DESCRIPTIVE REPORT

Type of Survey HYDROGRAPHIC

Registry No. H-11237

Sublocality Harris River Bay to Twelvemile Creek

Chart 17426, Location of 20- fathom curve deepening trend

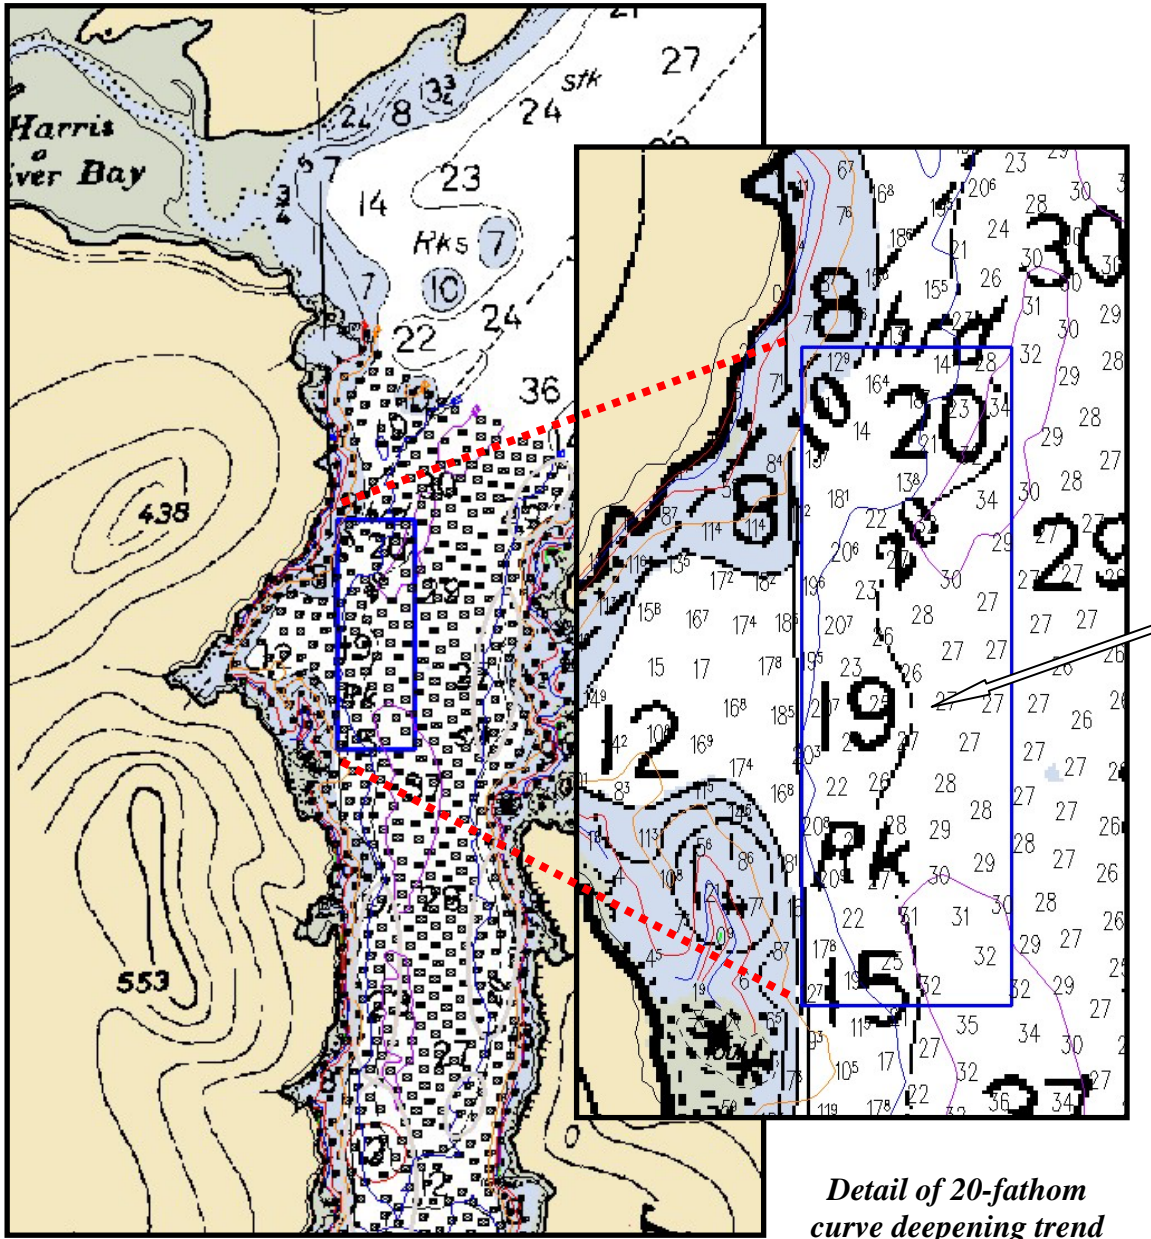
A review of the soundings and chart shows a deepening area in the¹⁶ 20-fathom curve below. A charted depth of 19-fathoms falls outside the 2003 20-fathom curve.

¹⁶ Strikethrough ~~in the~~, replace with “shoreward of the charted”.

Based on the results of survey H-11237, the Hydrographer recommends updating the next editions using the 2003 soundings to adjust the 20-fathom curve at the above location.

Chart 17426, Location of 20- fathom curve shoaling trend

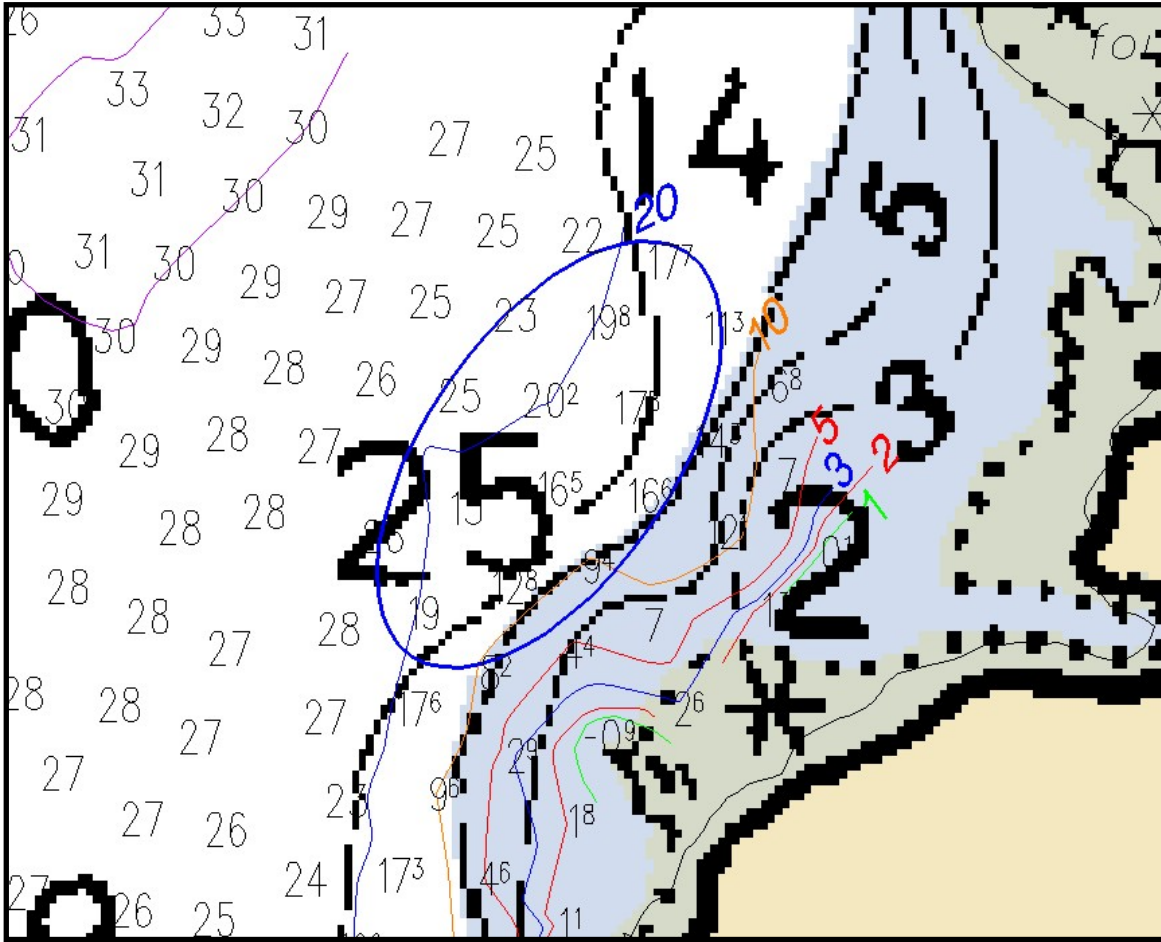
A review of the soundings and chart shows a shoal area in the¹⁷ 20-fathom curve located at the northeasterly end of the survey limits.

¹⁷ Strikethrough ~~in the~~, replace with “seaward of the charted”.

Based on the results of survey H-11237, the Hydrographer recommends updating the next editions using the 2003 soundings to adjust the 20-fathom curve at the above location.

Chart 17426, Location of 20-fathom curve shoaling trend

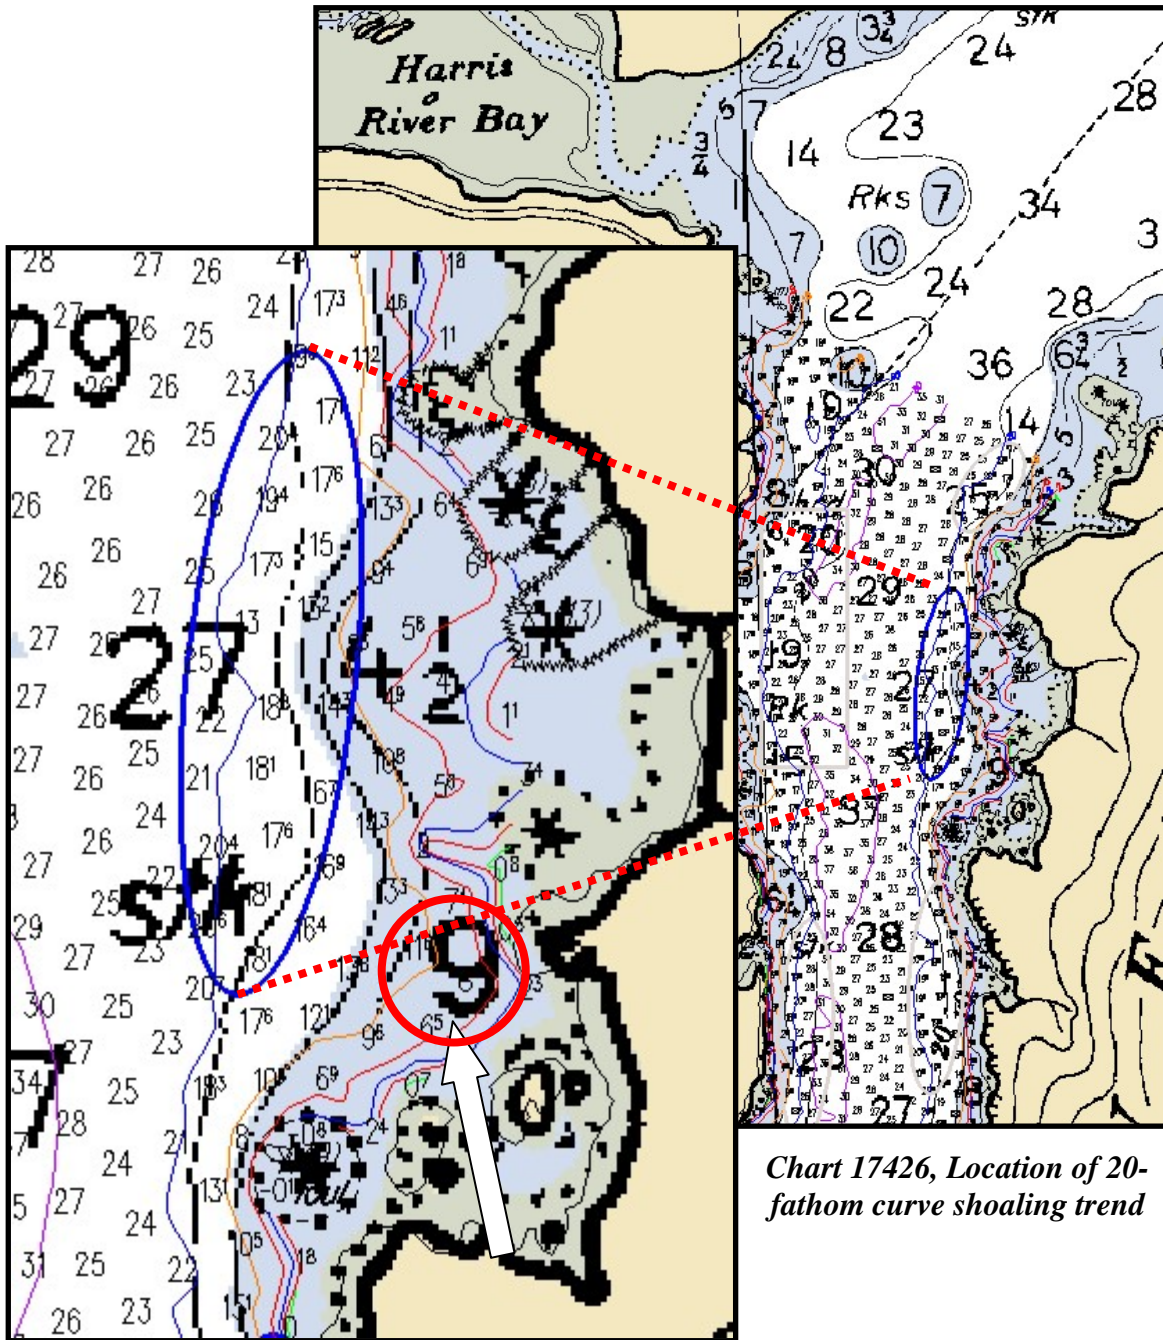
A review of the soundings and chart shows a shoal area in the¹⁸ 20-fathom¹⁹ below. Also noted is a charted 9-fathom depth inside the charted 5-fathom curve.

¹⁸ Strikethrough ~~in the~~, replace with “seaward of the charted”.

¹⁹ Insert “curve”.

Based on the results of survey H-11237, the Hydrographer recommends updating the next editions using the 2003 soundings to adjust the 5 ,10 and 20-fathom curves at the location above.

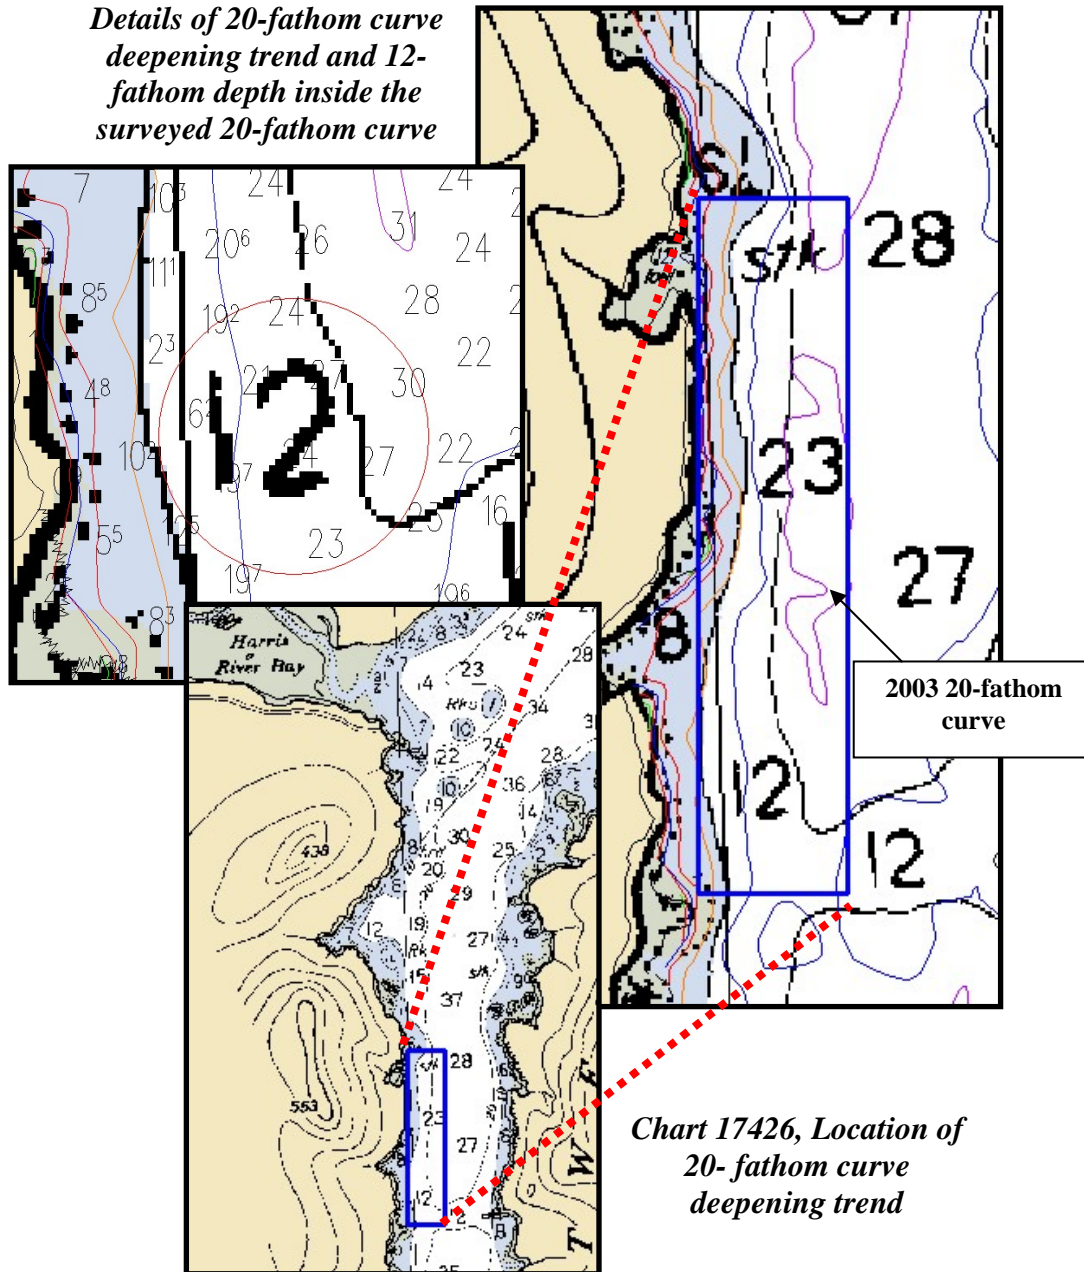
A review of the soundings and chart shows a deepening area in the²⁰ 20-fathom curve below. A charted depth of 12-fathoms falls outside the current 20-fathom curve.²¹

²⁰ Strikethrough ~~in the~~, replace with “shoreward of the charted”.

-
- ²¹ In the caption immediately below, ~~12 fathom depth inside the surveyed 20 fathom curve~~, replace with “12-fathom depth outside the surveyed 20-fathom curve”.

Based on the results of survey H-11237, the Hydrographer recommends updating the next editions using the 2003 soundings to adjust the 20-fathom curve, as well as updating the charted 12-fathom sounding with a 16 fathom sounding at the location above.

Chart 17426

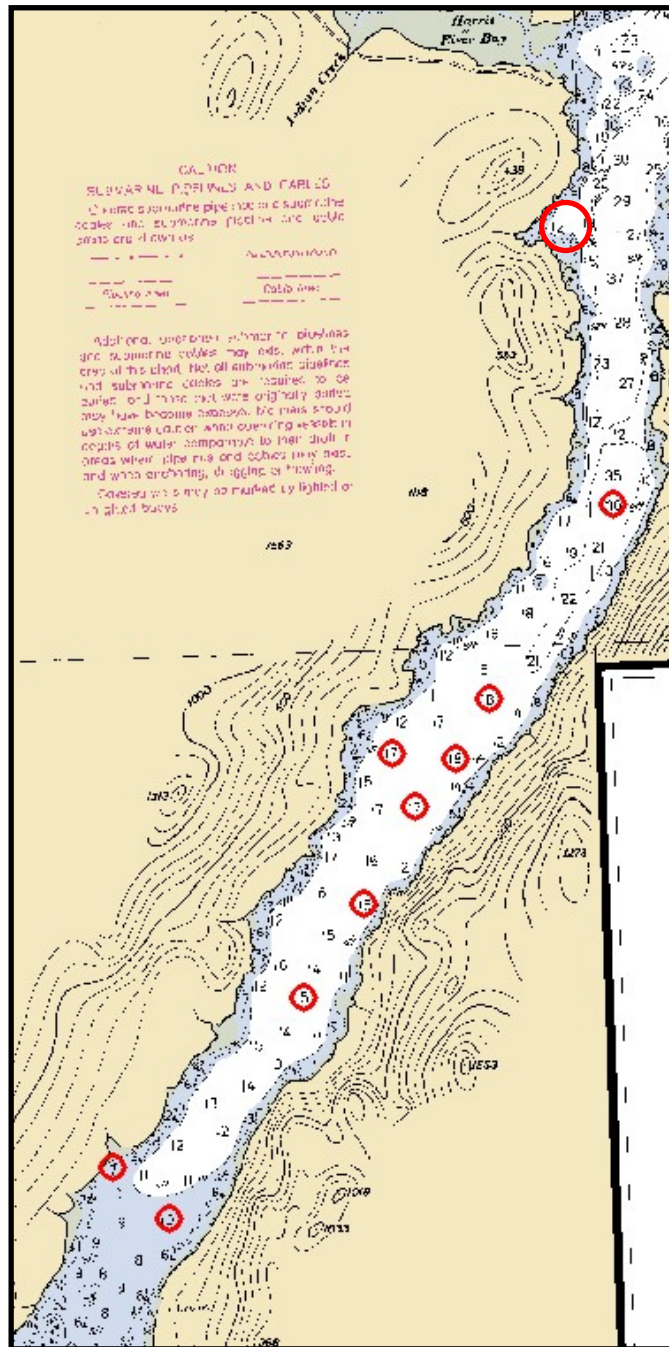
A review of the soundings and chart shows several charted values that differ from the soundings. These locations are circled in the detail below and described on the following pages.²²

- ²² Use smooth sheet positions, not general positions used in the discussion below.
- ²³ The latitude is incorrect. ~~Strikethrough 55° 22' 34"N~~, replace with 55° 22' 44"N.

A portion of Chart 17420 showing the charted versus RSD shoreline discrepancy

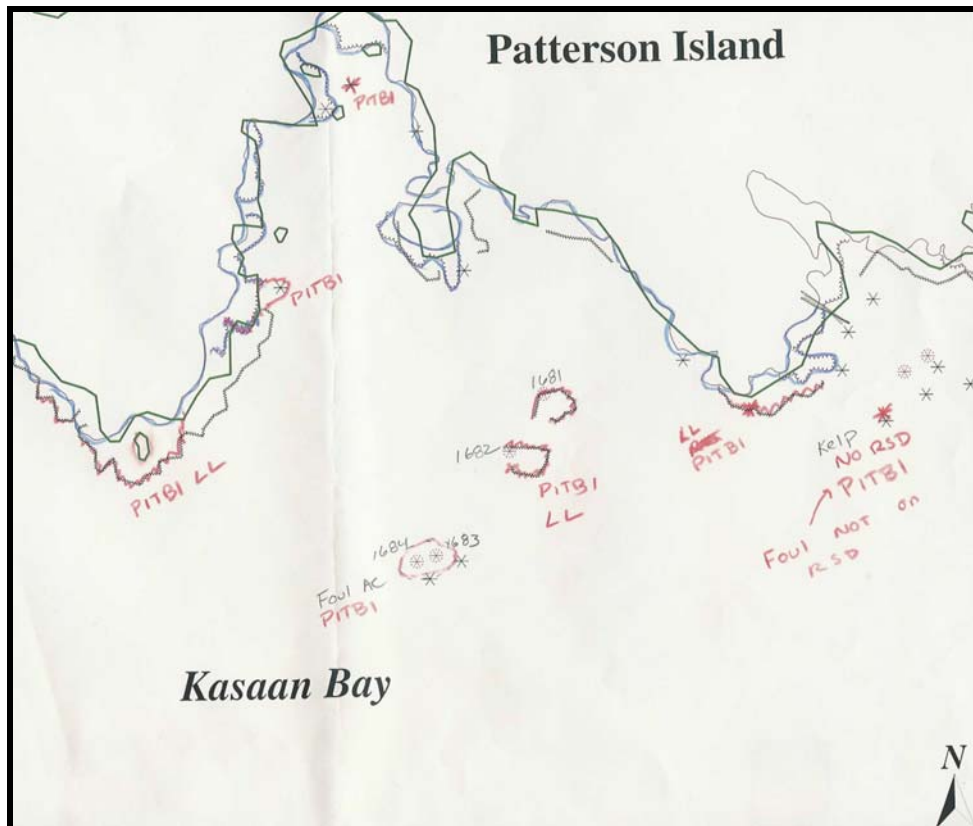
This survey generally agreed well with the chart. There were no outstanding disagreements with the depth curves or soundings. A comparison of the chart and remote sensing data does reveal a general discrepancy in the form of a shift in the shoreline. The charted shoreline is shifted overall to the north of the remote sensing data. The remote sensing data was verified through traditional and limited methods during this survey and was found to be accurate.

- ²⁴ ~~Strikethrough should be adjusted to~~, replace with “with”.
- ²⁵ Concur.
- ²⁶ Concur. Chart MHWL according to the smooth sheet.
- ²⁷ Chart all areas as portrayed on the smooth sheet and compiled to the Hdrawing except as noted.

Based on the results of survey H-11237, the Hydrographer recommends updating the next editions should be adjusted to²⁴ the 2003 RSD shoreline data.²⁵

AWOIS item 52774, radius, 2003 bathymetry, Chart 17426

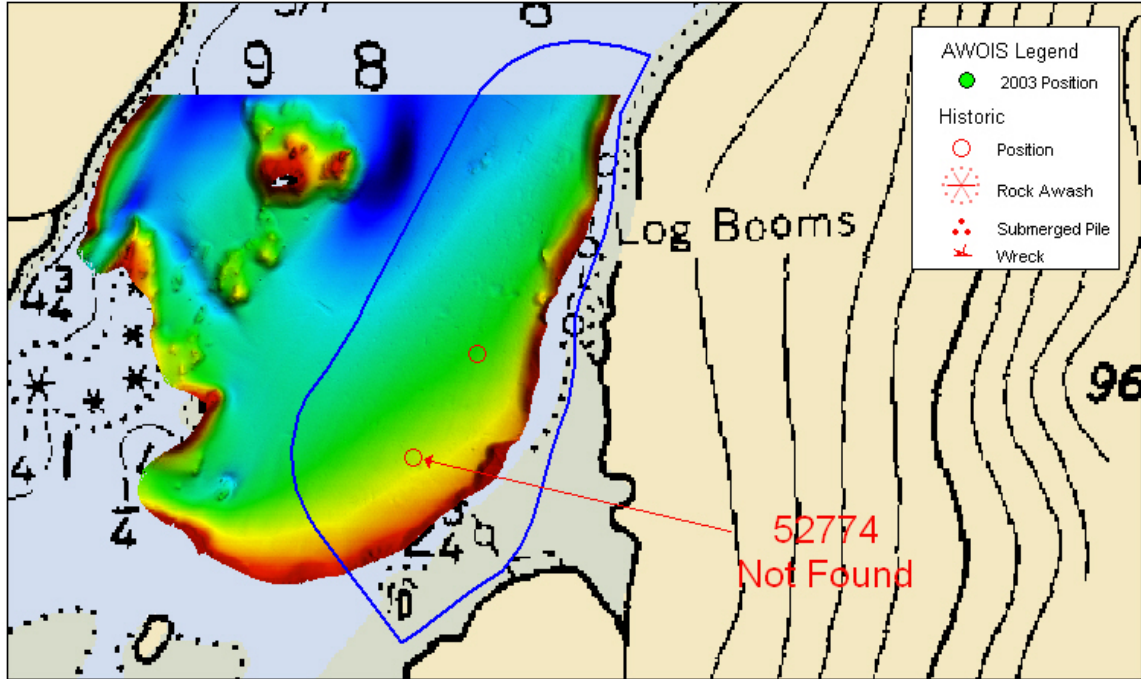
Date(s)/Day Number(s): 08/28/2003 / DN240
Survey Vessel Name: Skiff
Position Numbers/Time: 2071/09:17:52
Investigation Method: Shoreline Verification
Surveyed Position (NAD83): Lat 55° 22' 13.08"N Long 132° 43' 35.49"W
Position Determined By: Differential GPS
Investigation Summary: The charted position of this item fell outside the limits of hydrography.³⁸ The AWOIS radius was fully investigated by a combination of 200% SWMB coverage and visual shoreline investigation. A review of the digital terrain model detected no topographic relief. Remains of the log dump were found on the shore east of the AWOIS position.

- ³⁵ Concur.
- ³⁶ Concur. Chart according to the smooth sheet.
- ³⁷ Do not concur. Two AWOIS item investigations were required, as discussed below.
- ³⁸ Do not concur. The charted position stated in the AWOIS report, Lat 55/22/11.10N, Lon 132/43/34.42W, falls within the limits of hydrography.

Based on the results of survey H-11237, the hydrographer recommends the log boom symbol and notation be removed from the chart and database.³⁹

AWOIS item 52775, radius, 2003 bathymetry, Chart 17426

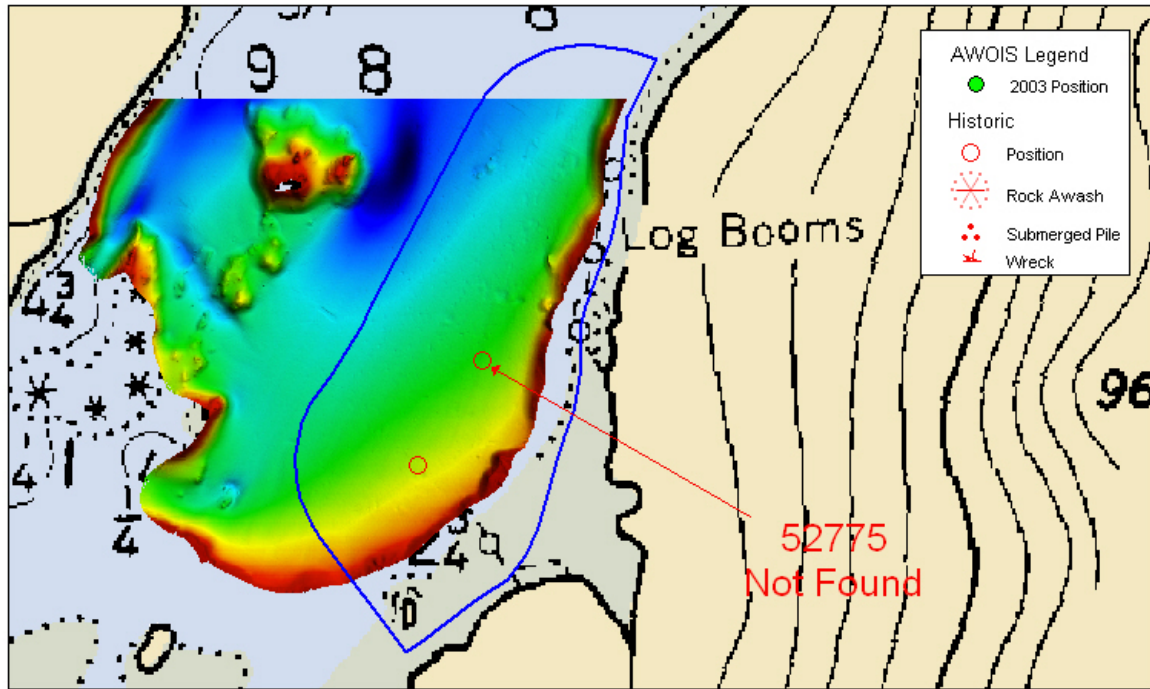
Date(s)/Day Number(s): 08/28/2003 / DN 240
Survey Vessel Name: Skiff
Position Numbers/Time: 2072/09:22:02
Investigation Method: Shoreline Verification and 200% SWMB coverage
Surveyed Position (NAD83): Lat 55° 22' 19.76"N Long 132° 43' 28.74"W
Position Determined By: Differential GPS
Investigation Summary: The charted position of this item fell outside the limits of hydrography.⁴⁰ The AWOIS radius was fully investigated by a combination of 200% SWMB coverage and visual shoreline investigation. Remains of the log dump were found on the shore east of the AWOIS position.

- ³⁹ Concur. See AWOIS form attached this report for further information.
- ⁴⁰ Do not concur. . The charted position stated in the AWOIS report, Lat 55/22/16.36N, Lon 132/43/28.22W, falls within the limits of hydrography.

Based on the results of survey H-11237, the hydrographer recommends the log boom symbol and notation be removed from the chart and database.⁴¹
